LME4981x Compact Amplifier

TITLE: lme49810_compact_amp	
Document Number:	REV: 2.1
Date: 2010-02-23 11:27:09	Sheet: 1/1

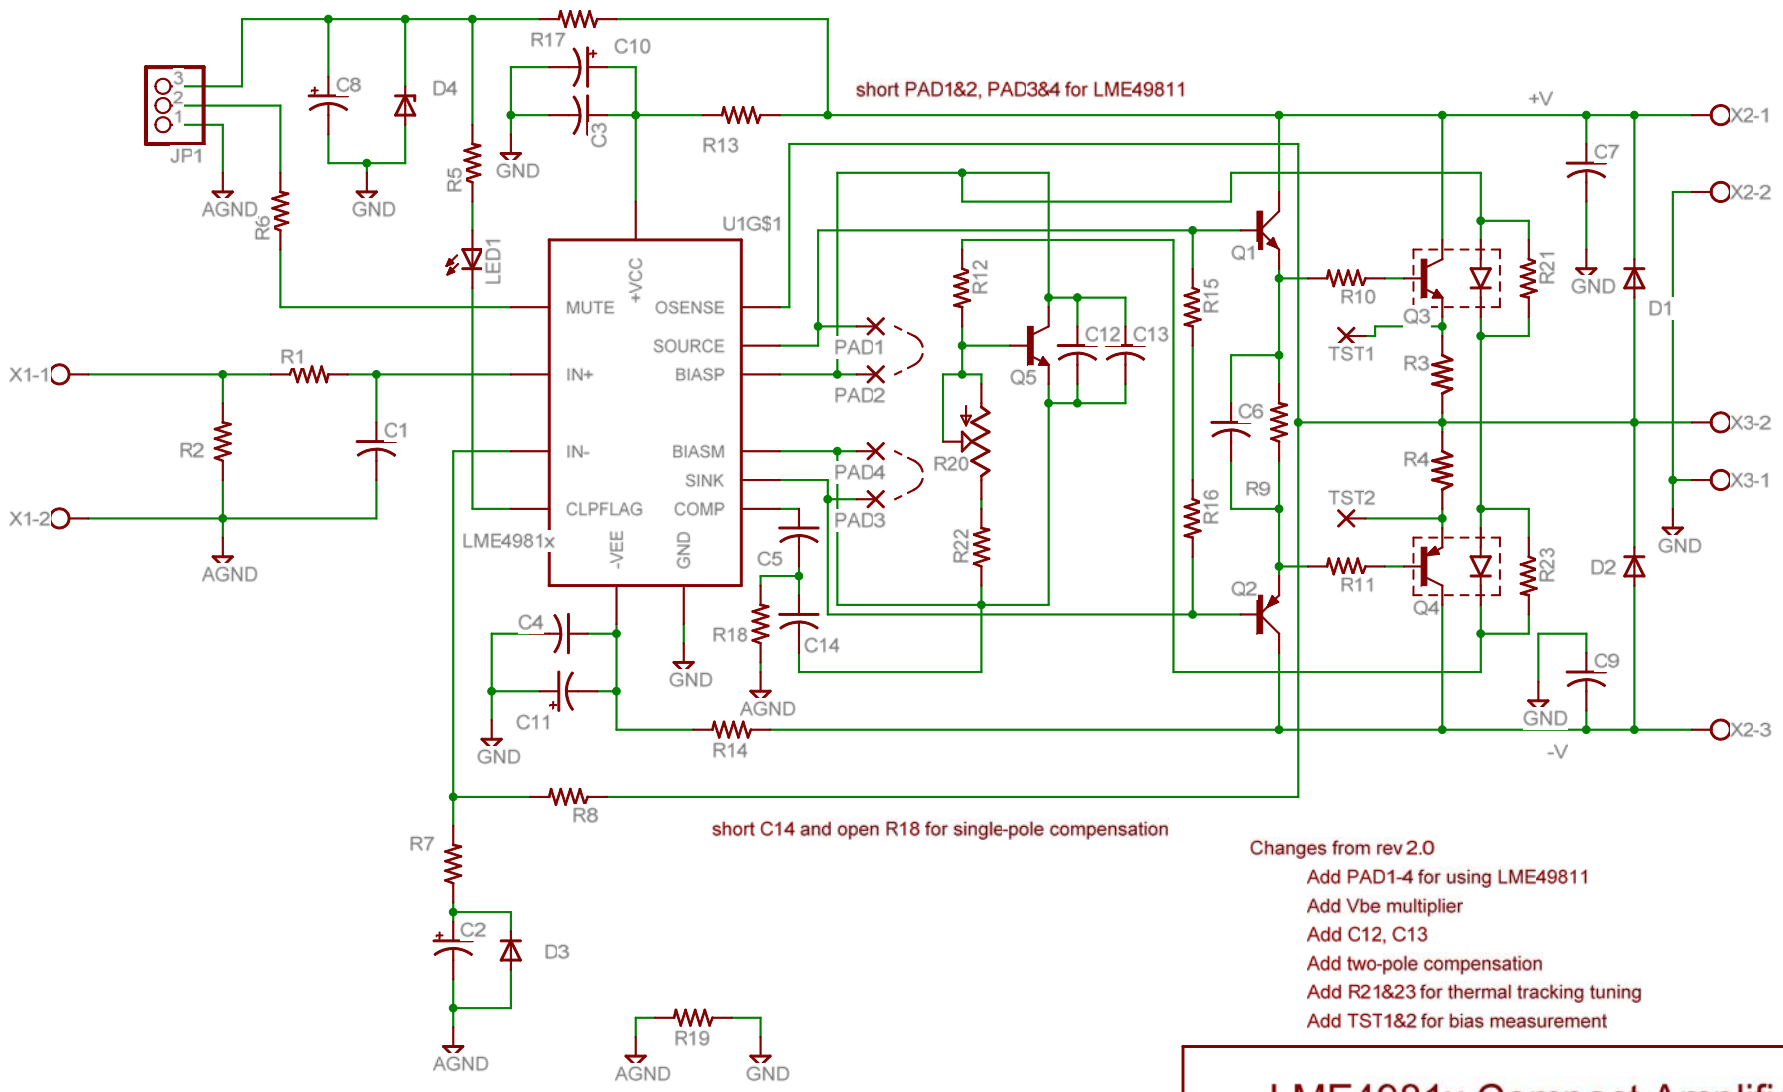
Changes from rev 2.0

- Add PAD1-4 for using LME49811
- Add Vbe multiplier
- Add C12, C13
- Add two-pole compensation
- Add R21&23 for thermal tracking tuning
- Add TST1&2 for bias measurement
